Item Name: Crosstube Turning Detail

DART AEROSPACE LTD		Work Order:	83089
Description: Crosstube Assembly (205/212/412 High Fwd)		Part Number:	D212-664-141
Inspection Dwg: D212-664-141 Rev: D		Page 1 of 1

DRAWING NO. D212-664-141	TITLE XTUBE ASSY (205/212/412 HI FWD)	REV. D	DART AEROSPACE LTD ENGINEERING ORDER		D.E.O. NO. D212-664-141-D-1	SHEET NO. SHEET 1 OF 2	SCALE NTS
DRAWN	CHECKED	AP	MFG. APPR.	ER	APPROVED	MP	DE APPR.
DATE 11.04.07	DATE 11.07.11		DATE 11.04.12		DATE 11/04/12		DATE 11.04.12

DRAWING NO. D212-664-141	TITLE CROSSTUBE ASS'Y (205 HI FWD)	REV. D	DART AEROSPACE LTD ENGINEERING ORDER		D.E.O. NO. D212-664-141-D-2	SHEET NO. SHEET 1 OF 1	SCALE NTS
DRAWN <i>UP</i>	CHECKED <i>ASS</i>	MFG. APPR. <i>AB</i>	APPROVED <i>MD</i>		DE APPR. <i>TH</i>		
DATE 11.07.15	DATE 11.07.20	DATE 11.07.21	DATE 11/07/21		DATE 11.07.21

**D212-664-141/-141B
ASSEMBLY DETAIL**

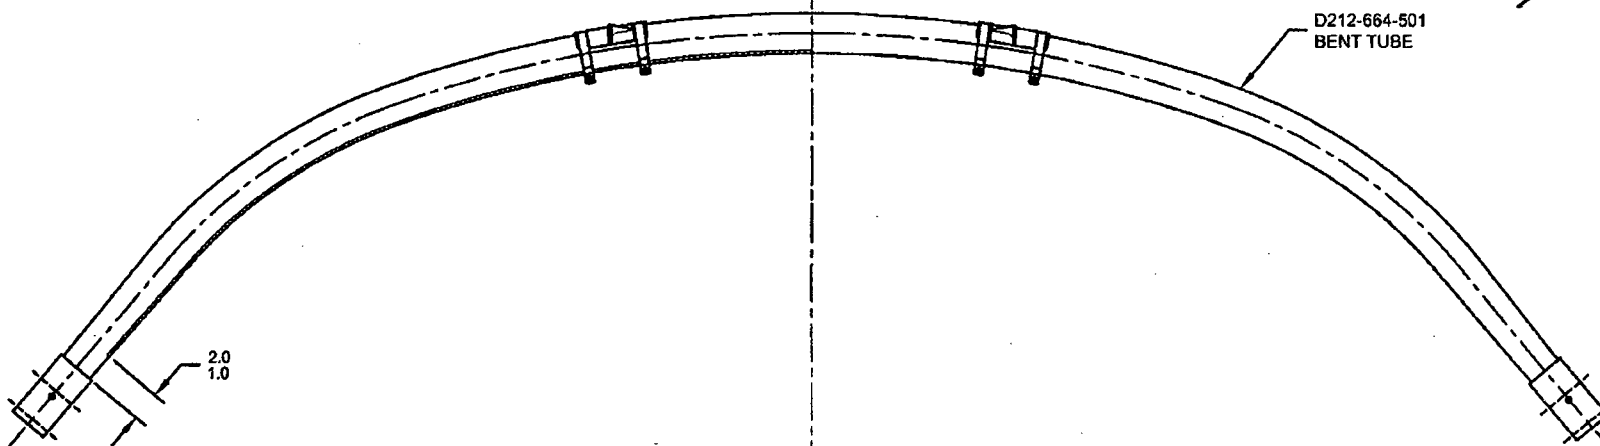
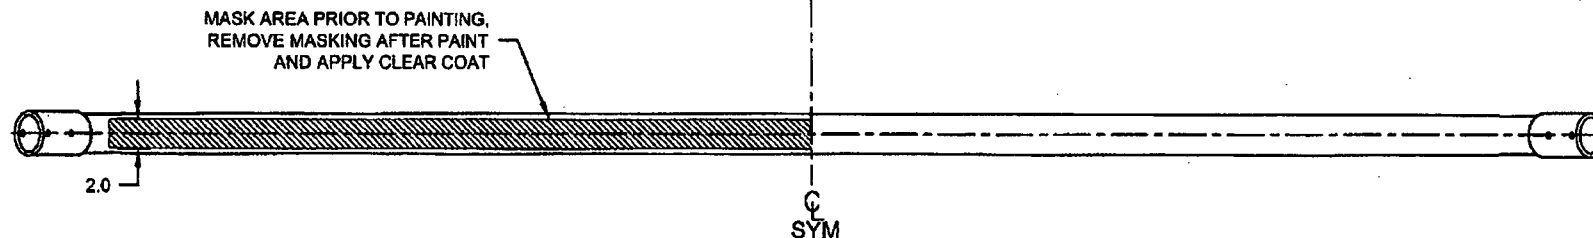
PURPOSE:

ADD AN INSPECTION WINDOW TO UNDERSIDE OF CROSSTUBE.

NOTES 2 OF SHEET 1 IS AMENDED AS FOLLOWS:

- 2) FINISH: CHEMICAL CONVERSION COAT PER DART QSI 005 4.1
PRIME INSIDE AND OUTSIDE PER DART QSI 005 4.2
MASK UNDERSIDE OF CROSSTUBE AS SHOWN (HATCHED AREA) AND
PAINT OUTSIDE PER DART QSI 005 4.2
REMOVE MASKING AND APPLY CLEAR COAT
